Review
of
CERCLA Cleanup
and
Decommissioning and Decontamination
at
Engineering Test Reactor
TRA Retention Basin
Materials Test Reactor
at
Reactor Technology Center
now
Called
Advanced Test Reactor Complex
Waste Area Group 2
Idaho National Laboratory

Submitted by
Chuck Broschious

May 2016
Revision G

In a major milestone for the project, the Engineering Test Reactor (ETR) was removed from the Reactor Technology Complex. Active from 1957–1982, the ETR reactor was used to evaluate fuels, coolant. DOE photo.

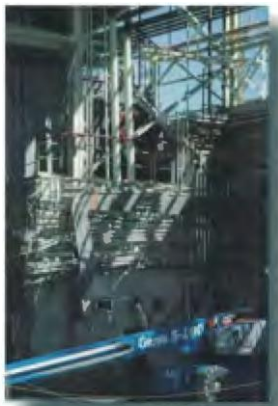
DOE's Risk Assessment document shows the Engineering Test Reactor (ETR) core slated for disposal at the ICDF contains 59,228.1295 curies of radioactive contamination.¹ This is a huge quantity of extremely deadly radioactive waste to dump over-top the Snake River Aquifer and within the Big Lost River flood plain. See Attachment below.²

DOE Risk Assessment document also states the ETR fuel core mass at 22,276 kilograms (22,276,000 grams).³ However, Engineering Design File uses ETR fuel core mass of 74,535,000 grams for calculating the total transuranic content of the core and the beryllium reflector.⁴ This is a significant discrepancy because it apparently radically understates the total nCi/g total applied to the ICDF Waste Acceptance Criteria limit of 10 nano-curie/gram limit.⁵ This discrepancy must be resolved due to the regulatory implications.

Additionally, "The [radioactive] transuranic activity in the [beryllium] reflector was determined to be 9.59×10^7 nCi [95,900,000 nCi]. It was obtained by multiplying the average transuranic specific activity for the reflector, 177 nCi/g by the total beryllium mass, 5.424×10^5 gram [542,400 gm]."⁶ This also puts the beryllium reflector into the Nuclear Regulatory Commission (NRC) definition of transuranic waste greater than 100 nCi/g that require deep geologic disposal.⁷ Dumping the beryllium reflector together with the ETR core violates both the ICDF WAC but also NRC regulations that require deep geological disposal of Transuranic waste.
